**APPLICATION OF WATERBRIDGE STATELINE LLC
TO APPROVE SALT WATER DISPOSAL
WELL IN LEA COUNTY, NEW MEXICO.**

CASE NO. 24568

NOTICE OF REVISED EXHIBIT PACKET

* Revised as of August 26, 2024 Per Technical Examiner's Request

Figure 1. Open Hole Log Snip of the Upper Confining Zone in the Lower San Andres Formation

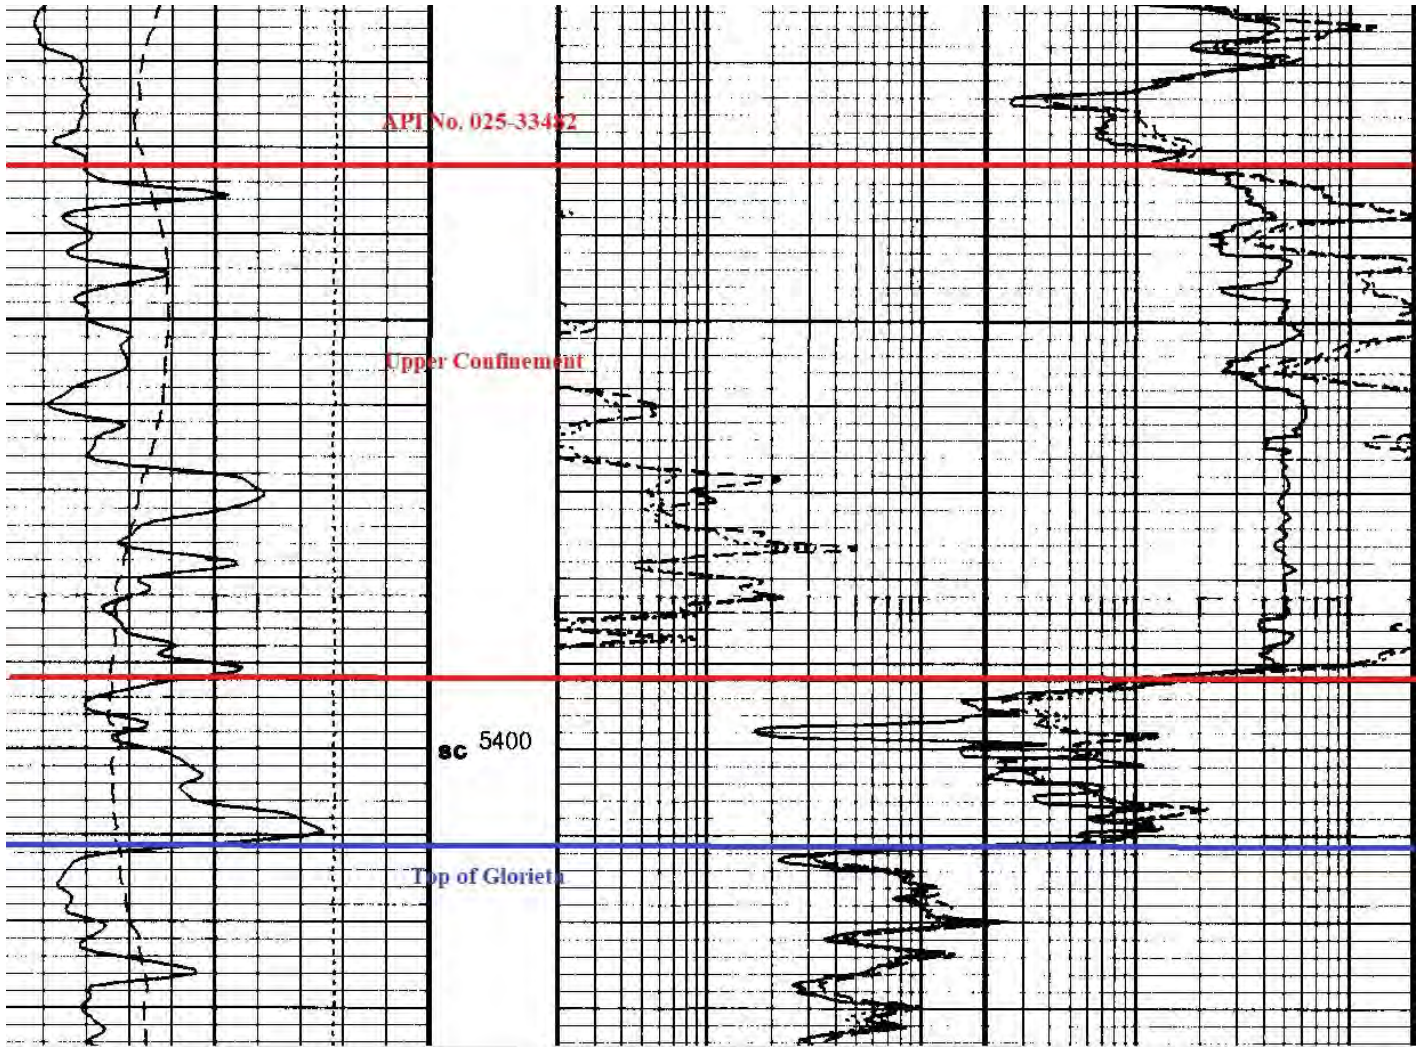
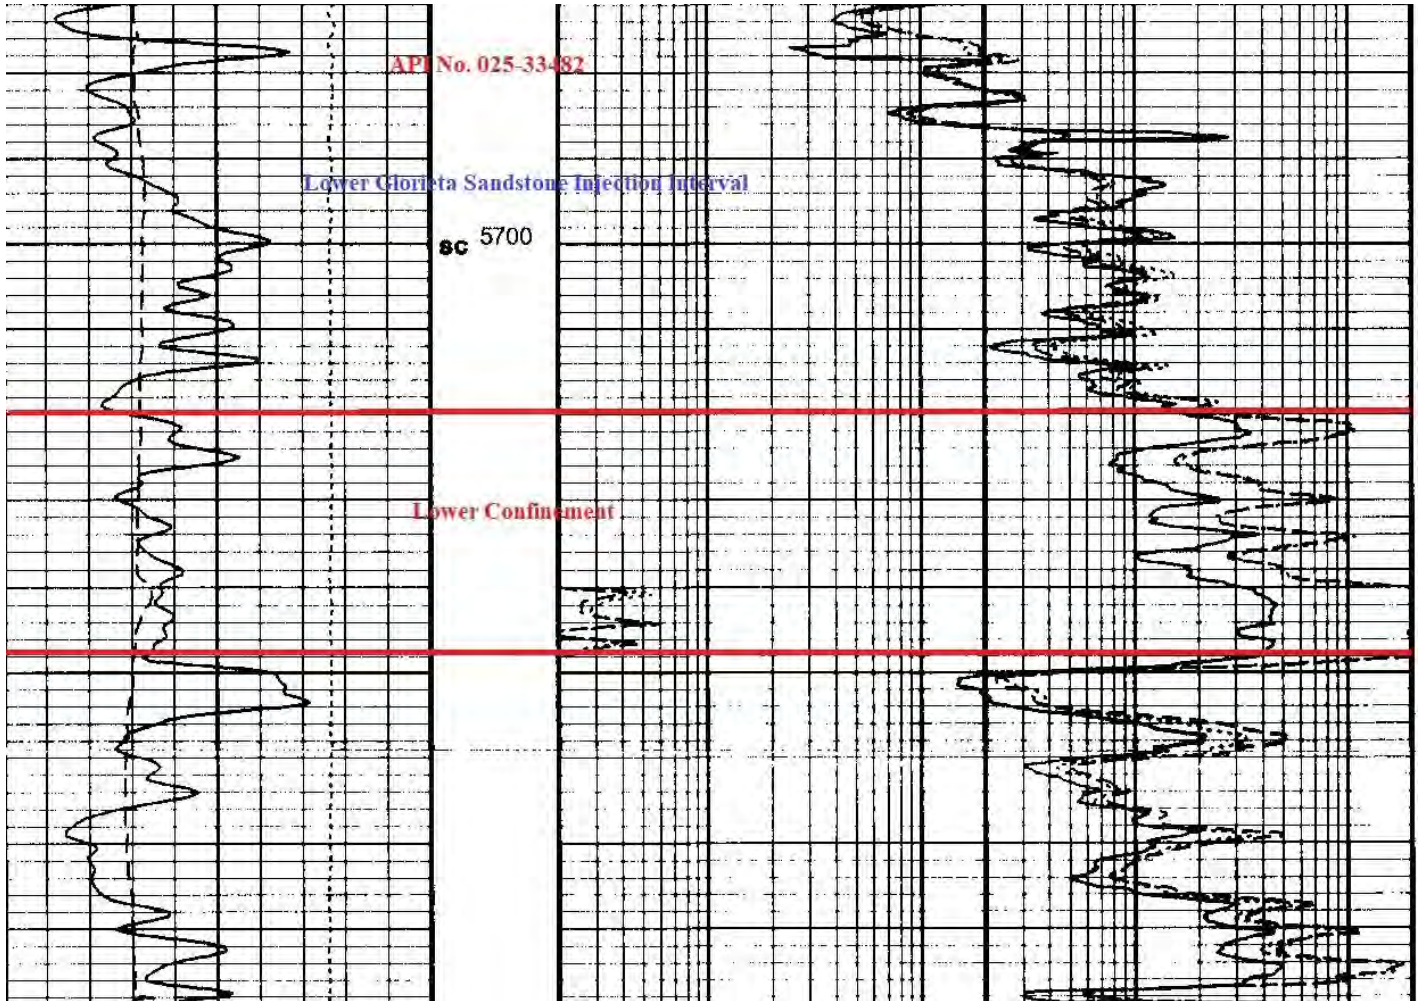
- Attachment 5: Revised to add a document entitled “Reservoir Characteristics at the FPNM SWD #1” which includes an analysis of porosity and resistivity of the upper and lower confining zones (see pages 35-36 of revised exhibit packet). This additional document also includes a statement from Waterbridge that Waterbridge will run a mud log on the FPNM SWD #1 as there is no current mud log data available within ½-mile. Waterbridge will provide that mud log to the Division.

The San Andres Formation is a shelf carbonate deposit composed predominantly of dolomite, and in the proposed development area, the lower San Andres Formation is a tight rock with low porosity and high resistivity values. **Figure 1** is a log snip of this upper confining zone of approximately 60 feet in the lower San Andres Formation. The lower confining zone is a tight sandstone unit within the Glorieta Sandstone, which also has low porosity development and high resistivity readings. The Glorieta Sandstone is a fine-grained, well-to-moderately sorted quartz arenite sandstone. **Figure 2** is a log snip of this approximately 30 feet of lower Glorieta Sandstone.
